***Special Use Permit #2024-00091
2701 Cameron Mills Road
Westminster Presbyterian Church***

Application	General Data	
Public hearing and consideration of a Special Use Permit for a cemetery and lot modifications.	Planning Commission Hearing:	March 4, 2025
	City Council Hearing:	March 15, 2025
Address: 2701 Cameron Mills Road	Zone:	R-8 Residential
Applicant: Westminster Presbyterian Church of Alexandria, Inc.	Small Area Plan:	Northridge/Rosemont

Staff Recommendation: Approval subject to compliance with all applicable codes and ordinances and the recommended permit conditions found in Section III of this report.

Figure 3: Rendering of south elevation showing proposed columbarium and fence locations

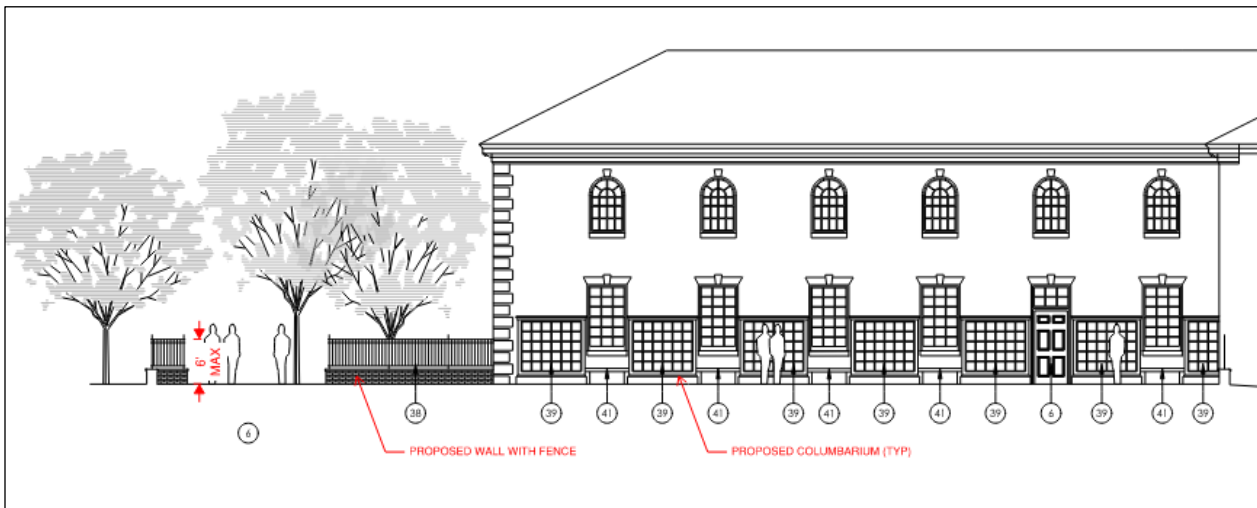
The applicant also requests SUP approval for two lot modifications. The first is to locate the columbarium 13 feet from the side lot line, where a 25-foot setback is required. Second, a six-foot, semi-enclosed fence proposed in the required front yard requires modifications as it exceeds the allowable four-foot maximum height for open fences.

The columbarium would consist of approximately 200 niches located on the south wall of the existing chapel building surrounding existing windows, as shown in Figure, having a depth of roughly 1.3 feet and a height of 6.8 feet. The columbarium would be accessed via a new sidewalk that would connect to the existing sidewalk for the chapel, as can be seen in Figure 4. Three benches would be located along the southern lot line and two benches would surround a fountain at the southwest corner next to the right of the chapel entrance. Brick pavers would extend from the walkway to the edge of chapel/parlor structure and create a space for small gatherings of between five to 15 people who would attend services that would take place between the hours of 10 a.m. and 2 p.m. The fence would extend around the walkway and the area for gatherings.

As noted in the proposal, the semi-closed six-foot side and front yard fence would be composed of brick and iron railings in an attractive design. The fence, along with shrubs and trees, would provide a screen to the areas where mourners would gather. Staff support the lot modification for a 22-foot long front yard fence height of up to six feet and semi-closed, as opposed to a permitted open and four foot fence, to provide privacy for congregants during funeral services. Additionally, this six-foot section of fence would only occupy 10% of the overall church frontage, and as such, would keep open the lovely view of the church property and open space.

Figure 4: Design concept for the columbarium and fence locations

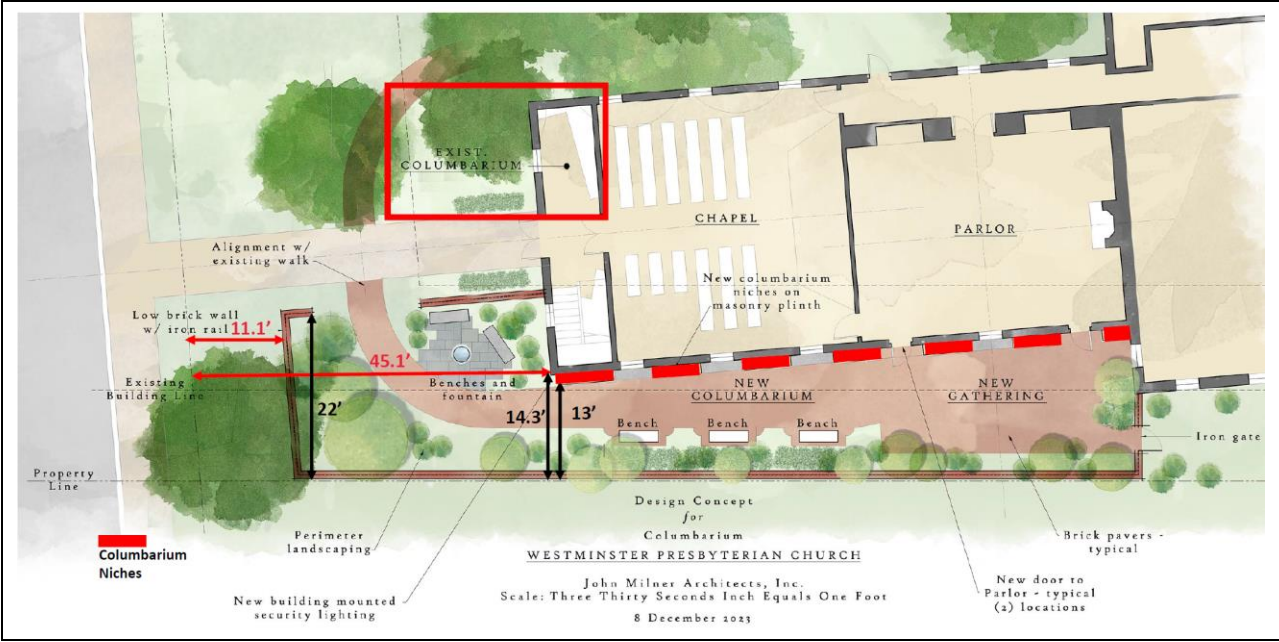
The applicant has indicated that there were a number of considerations in the church's choice to locate the columbarium near the southern side lot line. There is an existing columbarium located in the narthex of the existing chapel and maintaining proximity to this columbarium was important to the church. Additionally, the chapel is used to conduct memorial services, so locating the columbarium with direct access to the chapel was a key consideration. The church discussed the courtyard on the north side of the chapel as an alternative location, but that space is used for many alternative functions, for both the church and neighbors. It was felt that a number of these functions, including the walking of dogs and various gatherings, would not be conducive to the quiet, reflective space sought for the columbarium. Areas of the site to the north and east of the church placed the columbarium distant to the chapel as well as adjacent to large areas of parking or heavier street traffic. It was felt that the south side of the chapel offered a more secluded, private space that could be screened effectively and accommodate the adjacencies to the existing columbarium and chapel.

Neighborhood impacts are not expected from the columbarium addition as the service hours would be limited to between 10 a.m. and 2 p.m. and with an expectation of no more than 15 congregants at a service. Other times the area would serve as a place of quiet visitation. The columbarium use is a distance away for the school at approximately 130 feet from the closest school building section. Residential uses, also are not nearby. Staff agree that this is a reasonable location for the columbarium at only 1.3 additional feet closer to the side yard lot line than the existing building face.

PROPOSED CONDITIONS
 SHEET **2** OF **2**
 FILE: **24-133**

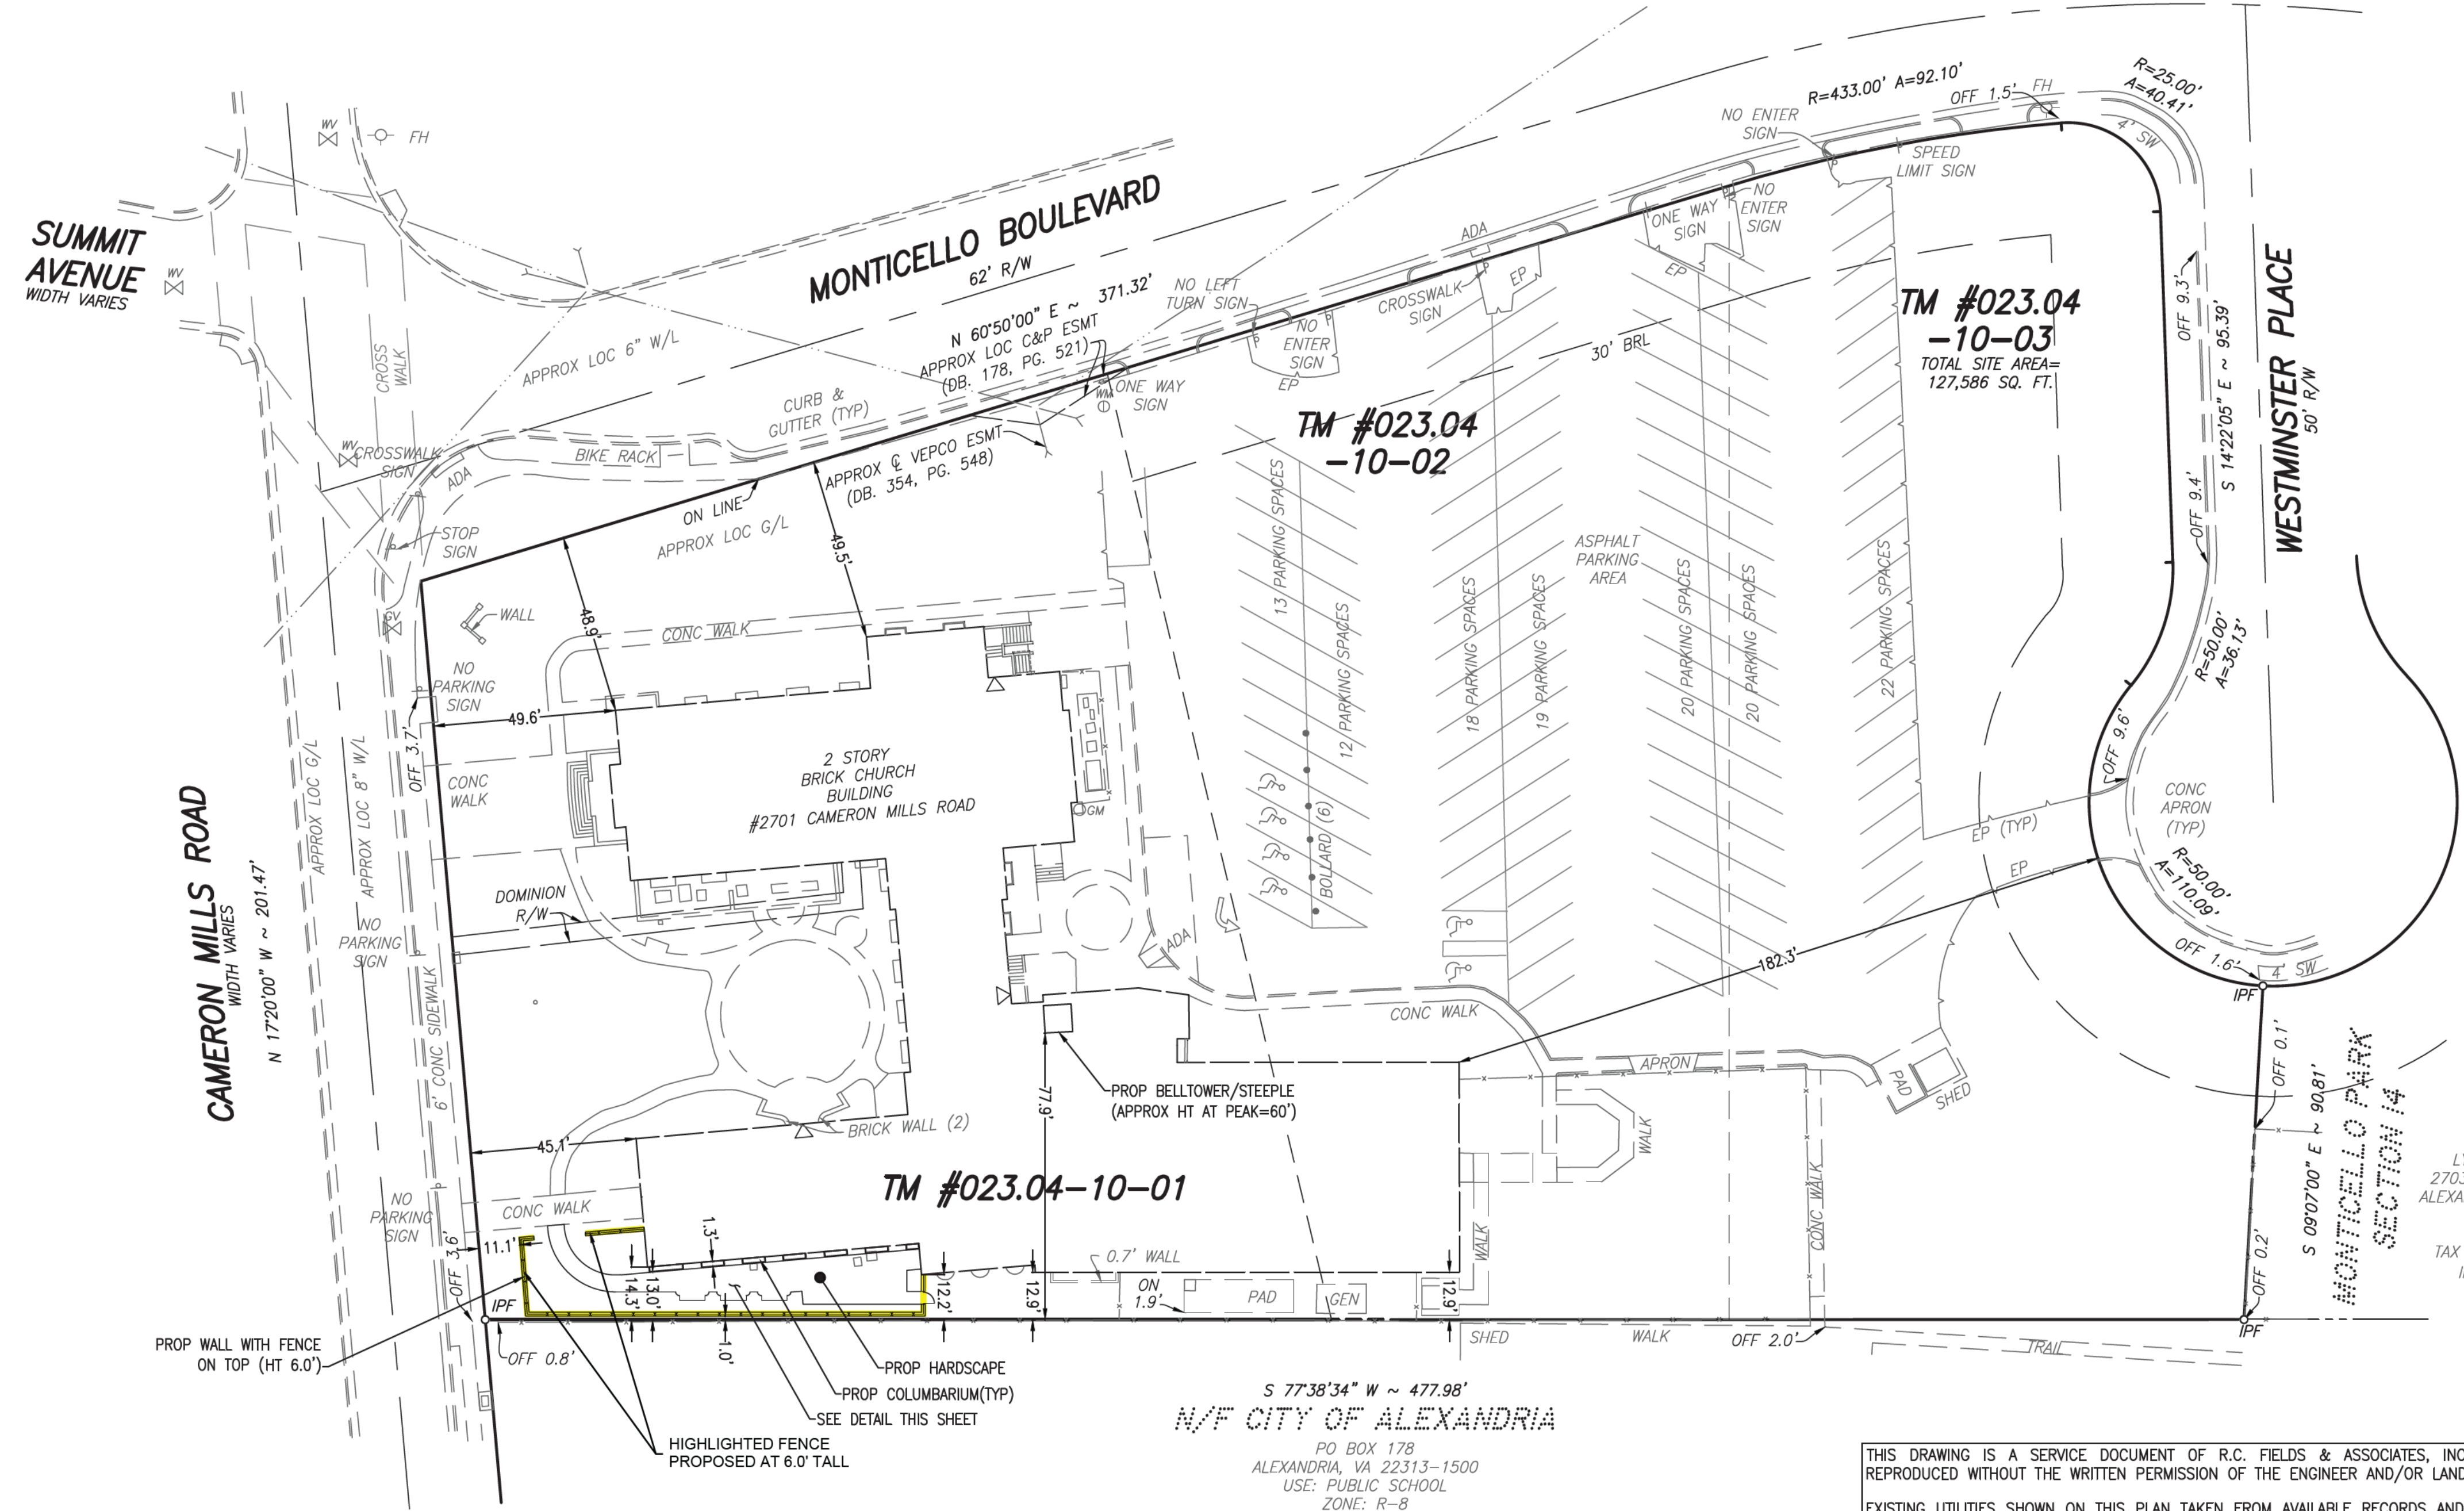
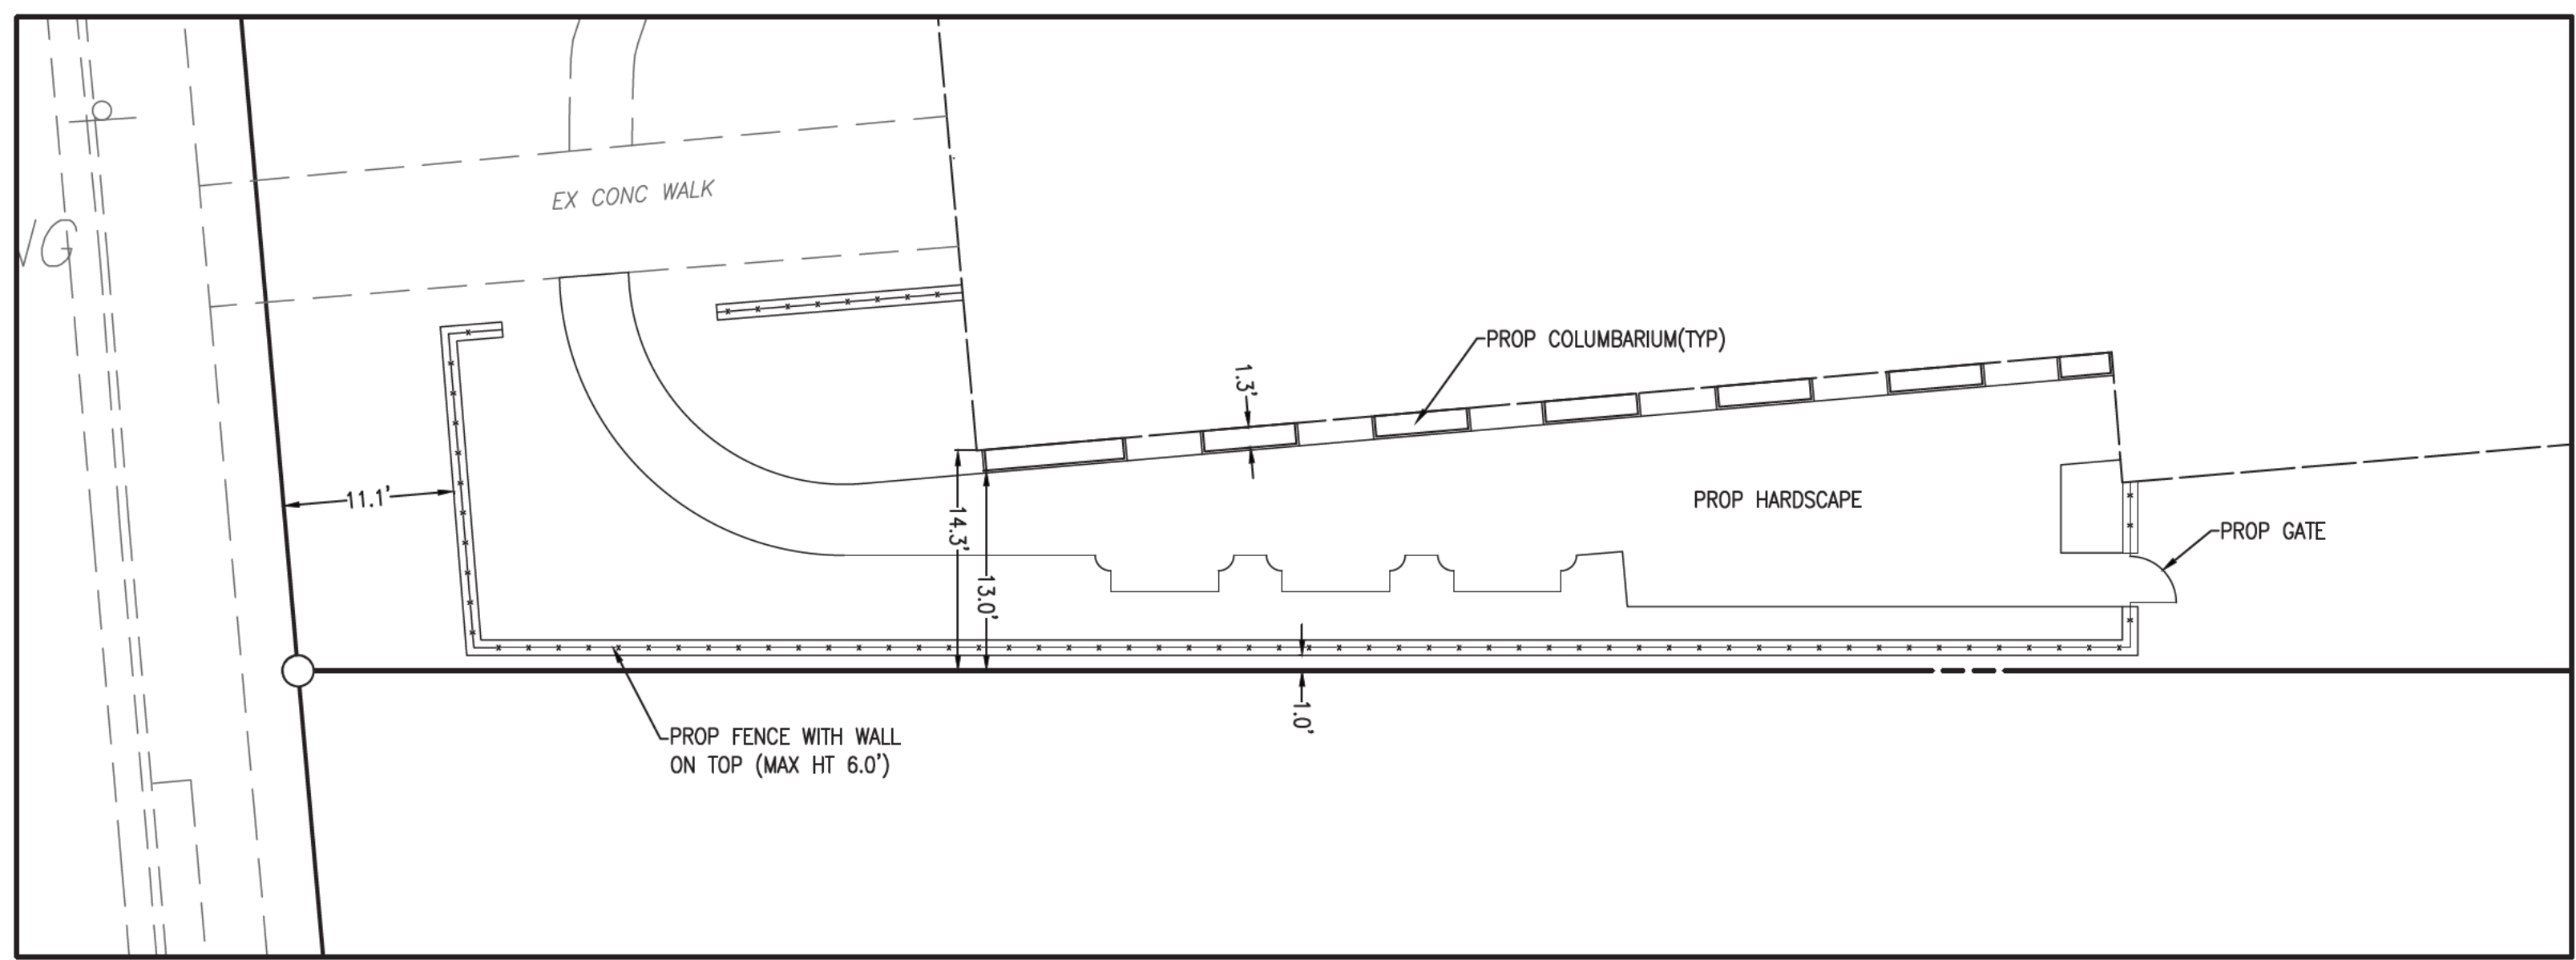
Proposal is a 6' high semi-enclosed fence in the front yard to secure privacy for columbarium services that will be held just beyond the fence. The current front yard at this location is 45.1' and it will be reduced to 11.1' along 22' of the front yard, where the requirement is 30'. The required front yard in this area is reduced by 19.9', or 66.3%. Considering that the width of the entire front yard is a little over 200', as staff notes, only about 10% is below the minimum 30' and thus the modification will "keep open the lovely view of the church property and open space." Staff Report at 4. I further agree that Staff has correctly referenced 7-202(A)(1) as the Ordinance provision for which modification is sought. This, however, is not, as Staff suggests, a "lot modification request." The lot is not being modified by the fence; the fence would not be permitted in the R-8 zone without its being approved under the SUP criteria, which are implicated here because a cemetery (including a columbarium) is permitted in the R-8 zone only via an SUP,

[I note also that while Staff did not delineate the actual magnitude of the modification requested, it correctly did not regard the application as merely a two-foot change in the fence height, as suggested by the applicant. As detailed above, a 6-foot fence in the front yard is not a permitted use in the residential zones. Further, modification of the site plan that controls development on this property is governed by 11-416, as staff acknowledges. The Commission's modification authority, as set forth in 11-416(A)(1), is limited to modifying minimum development requirements, including numerical frontage, yard, and open space requirements. The Commission does not have the authority to authorize, as a site plan modification, an accessory use where it is expressly prohibited—in this case, a 6' fence in the front yard.]

Regarding SUP #2024-0009, Land Use Services staff clarifies that the six-foot fence at 2701 Cameron Mills Blvd. is a modification of the lot’s front yard requirement, also referred to in the staff report as a lot modification. Nonetheless, staff believes the description of the modification in the staff report clearly and specifically identifies the request as related to the front yard requirement and generically to the lot. Staff maintains its recommendation of approval.

Because a fence cannot exceed four feet in height within a required front yard, the applicant requested a modification to the required front yard to be decreased to six feet instead of 70 feet. Section 11-416(A)(1) states that the Planning Commission may modify the minimum yard requirements, which staff interpret to mean Planning Commission can decrease the depth of a required yard. Section 11-416(A)(2) reinforces this interpretation, as it states that the Planning Commission does not have the authority to approve a site plan when a building or structure would exceed maximum FAR, maximum density, or maximum height regulations of the zone- the fence would not exceed any of those maximums. Section 11-416(A)(2) also states that it is the “the intent of this section to allow regulations expressed as minimums such as yard dimensions to be relaxed in the proper case but not to allow regulations expressed as maximums such as density to be increased.” It is Staffs’ belief that the Planning Commission does have the authority to grant a modification that decreases the minimum yard requirement as it does not change nor impact lot area, floor area, or density.

To ensure additional clarification, Staff recommend a new condition: The requested modification would only allow the proposed fence.
